URGENT MEDICAL DEVICE CORRECTION

GEHC Ref# 10903

RE: **Potential fall of single/dual LCD monitor by detaching from suspension.**

Rearview Single Monitor Mount
Location of 4 mounting screws

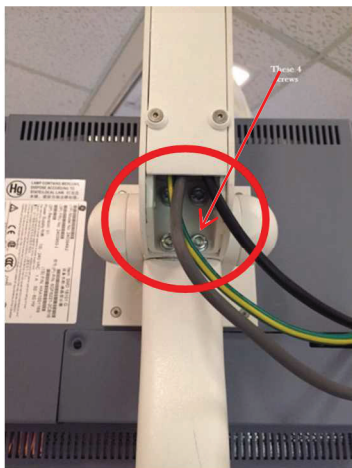
Perform a visual check before and after each use for the presence of the four (4) mounting screws as shown in the pictures below. Check the secureness of these screws by hand. If these screws are present and secure, you may continue use of the system.

If any of these screws are missing or can easily be turned by hand, follow the precautions below before you continue use with the monitor(s).

1. Position the monitor suspension in the most frequently used position and limit further movement as much as possible.
2. Clearly inform (e.g. through signage and verbal instructions) the users and other auxiliary personnel who may come in contact with the system to **not move the monitor suspension once in position.**
3. Contact your GE Healthcare representative to inform them of any loose or missing screws.
